**Preliminary Alternative Technical Concepts (ATC) Submittal**  
**BEL-70-9.35 Interchange Improvement**  
**Design-Build**  
**Belmont County, Ohio**  
**PID 120547**

## Contents

SITE PLAN  
BRIDGE NO. BEL-70-0963 L/R  
I.R. 70 OVER S,R, 149

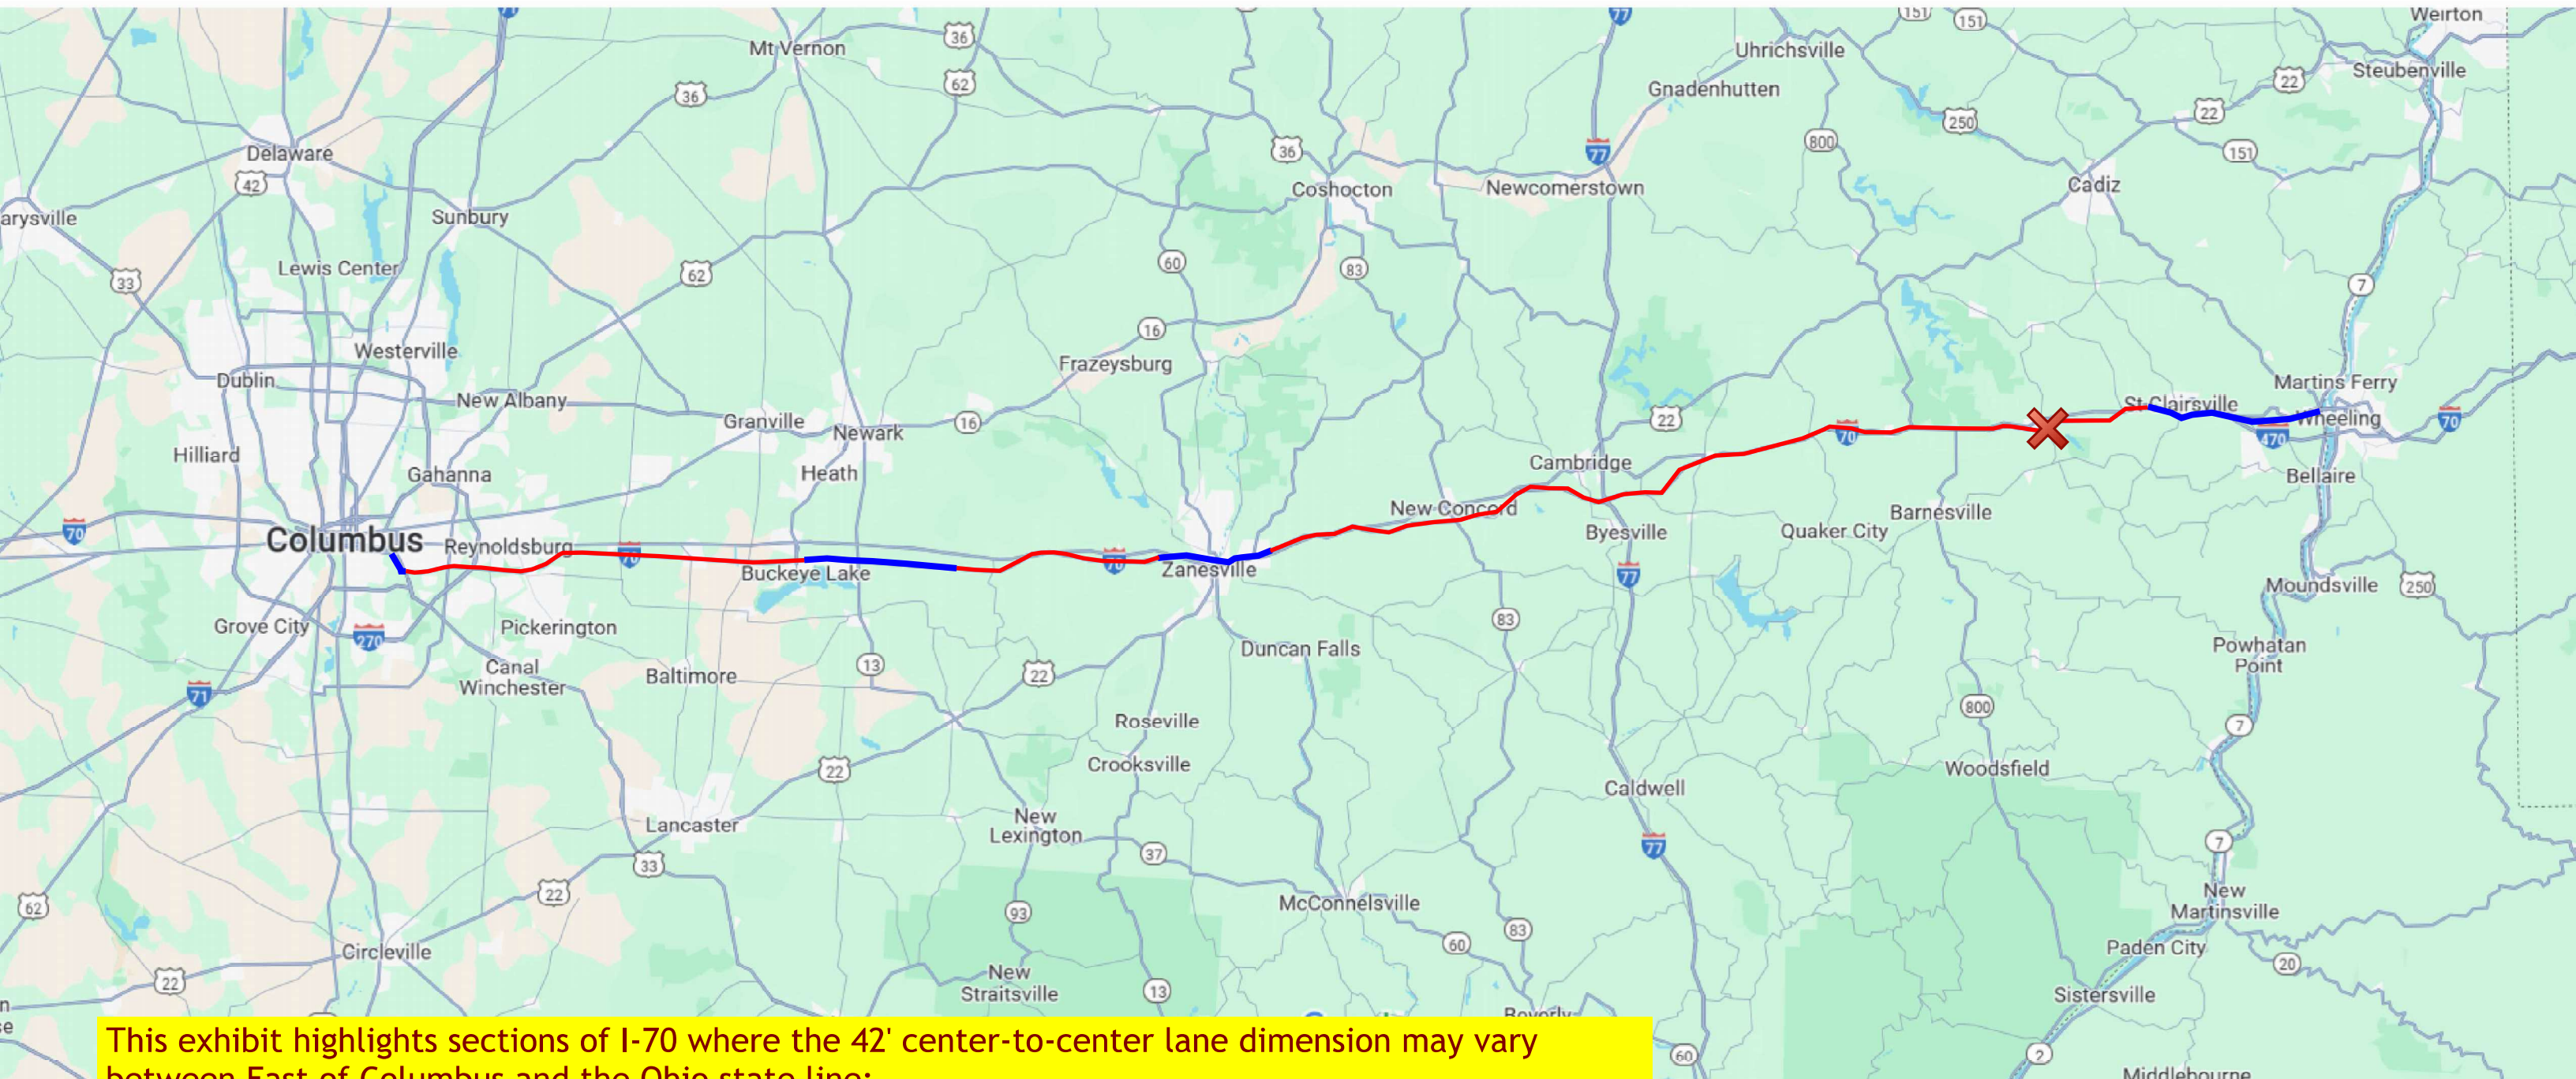
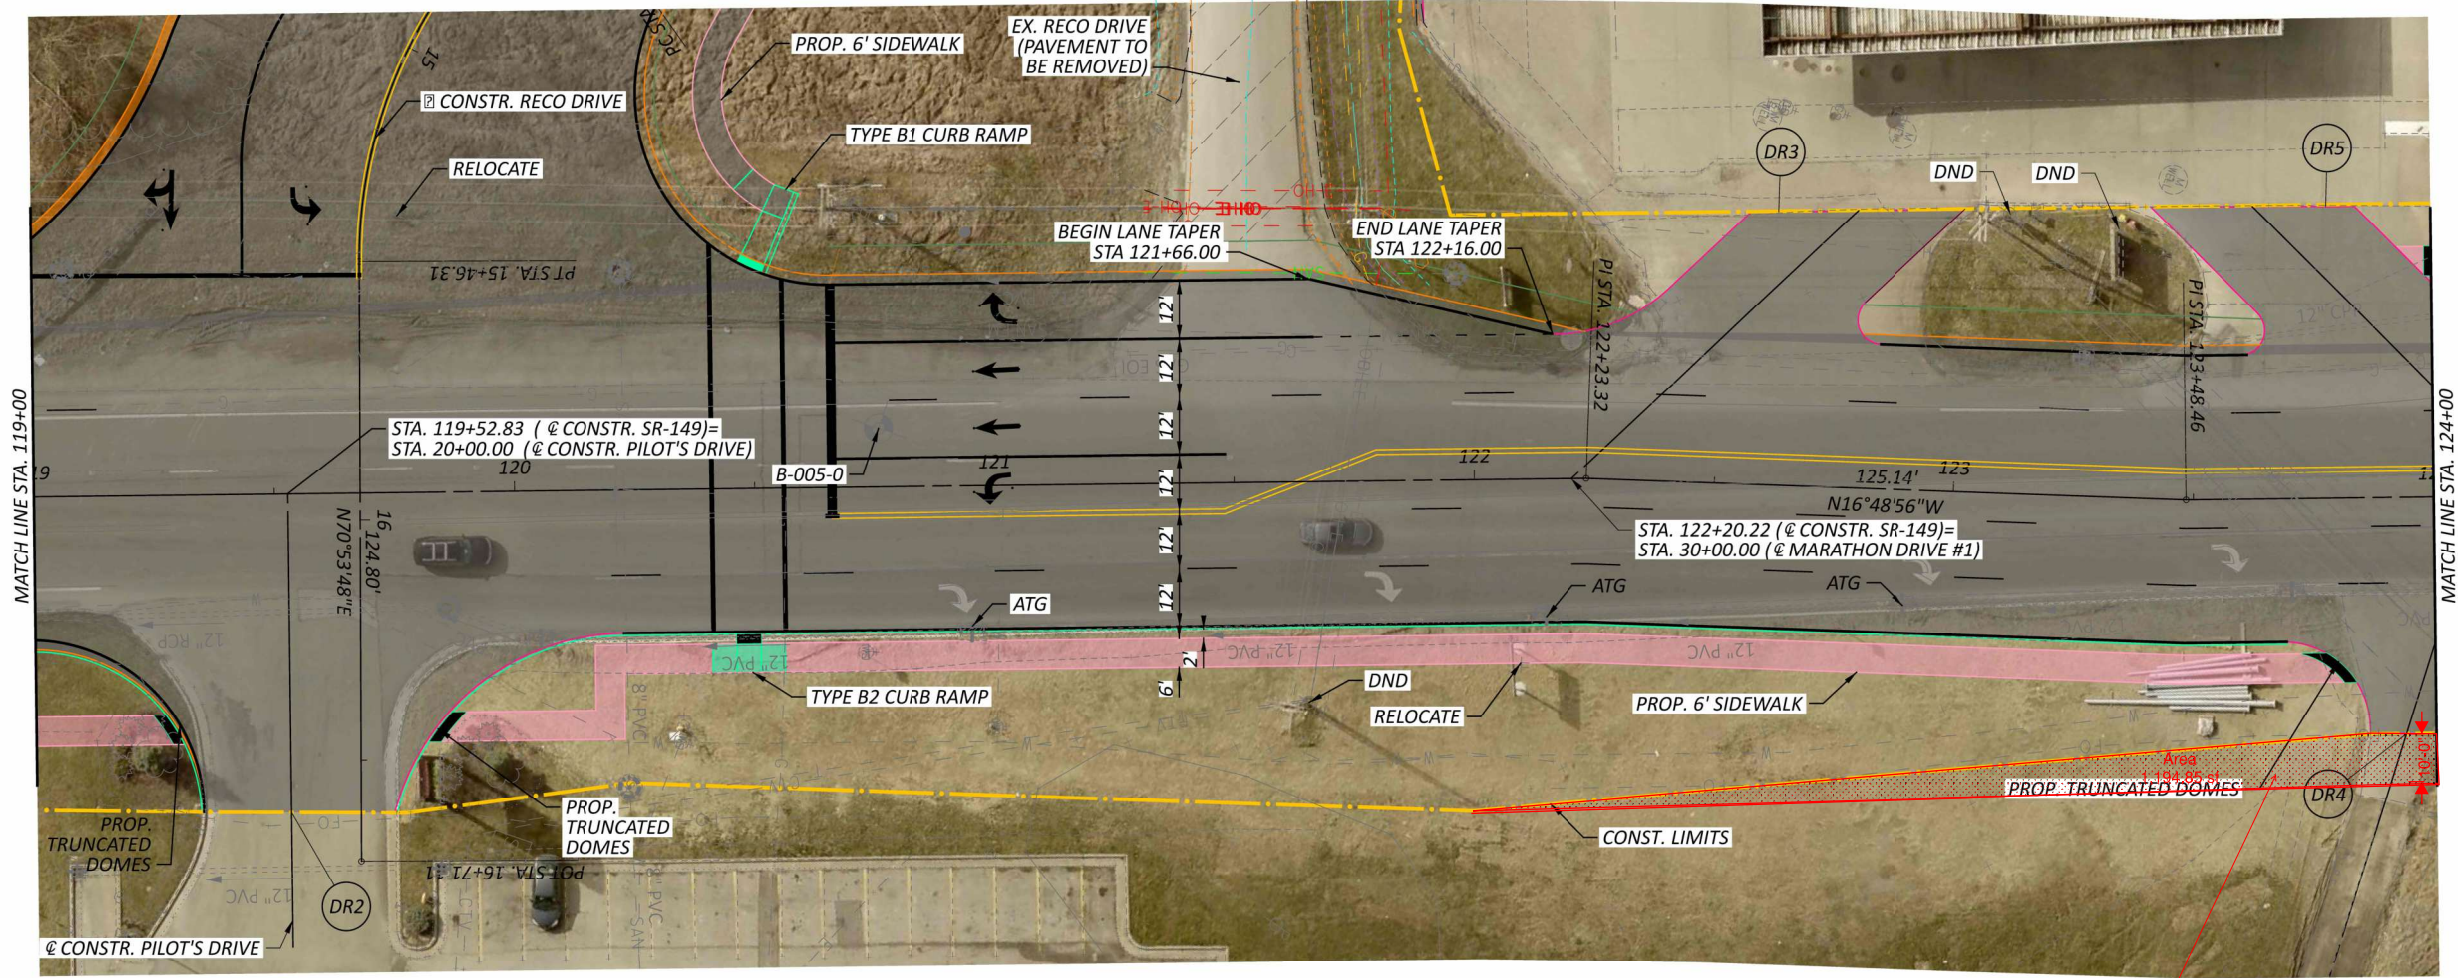
1. **Description:** This ATC proposes a modification to the bridge design requirements outlined on Page 43 of 63 of BEL-70-9.35, PID 120547 SCOPE OF SERVICES (Addendum 1). The original specification mandates that all new bridges must be 3-span continuous composite steel beam structures with no skew, and no other structure type is permitted. Additionally, the eastbound and westbound bridge span arrangements must match.

The DBT proposes revising these requirements to allow for alternative structure types, such as a single span bridge, to be considered. This modification will provide flexibility in the design process. This approach could also lead to more cost-effective, innovative, or constructible solutions while still maintaining the requirement for consistency between the eastbound and westbound bridge span arrangements. The proposed change ensures the final design will meet project objectives while allowing the DBT to explore optimized structural options. See Exhibit B for additional details.

2. **Deviation:** Page 43 of 63 of BEL-70-9.35, PID 120547 SCOPE OF SERVICES (Addendum 1) states: *"New bridges must be 3-span continuous composite steel beam structures with no skew. No other structure type will be allowed. The eastbound and westbound bridge span arrangements must match."*

The DBT proposes modifying this language to: *"New bridges may be designed as 3-span continuous or single span composite steel beam structures with no skew. The eastbound and westbound bridge span arrangements must match."*
